REMARKS

Attorney Docket No. 10541/277
Applicant(s): Jairazbhoy et al.
Filed: April 6, 2001
For: EVAPORATIVE COOLING DEVICE AND METHOD

FIG. 1B

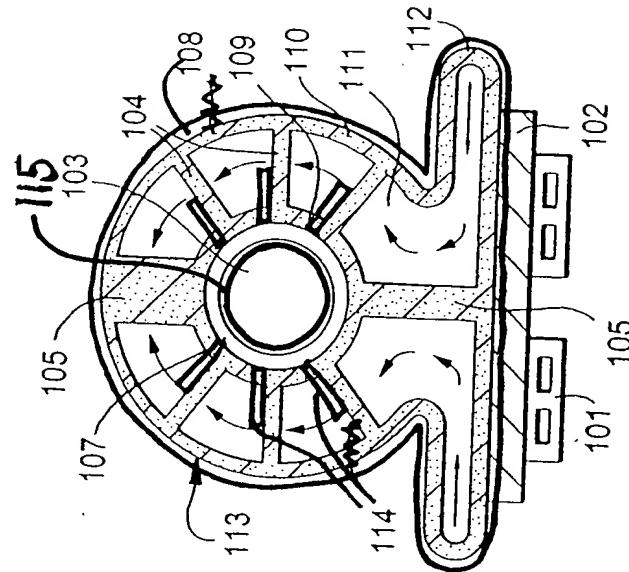
The Examiner objected to the drawings on the basis that figure 1B, "which is a cross sectional view of figure 1A, does not disclose the cooling conduit (115) that is shown in figure 1A." Pursuant to 37 C.F.R. § 1.121(d), Applicants respectfully submit

the enclosed proposed drawing corrections of figure 1B in response to the Examiner's objections.

Two versions of the proposed drawing corrections are being submitted. The first, labeled "Version 1", reflects (in red) the presently proposed drawing corrections as well as the previously proposed drawing corrections to figure 1B submitted with Applicants' April 25, 2002 response to the Office Action mailed February 27, 2001. The second, labeled "Version 2", only reflects (in red) the presently proposed drawing corrections.

The Examiner's objection is addressed with the presently proposed changes shown in red. Applicants respectfully request approval by the Examiner of the proposed drawing corrections. No new matter has been added as these changes are supported in the specification.
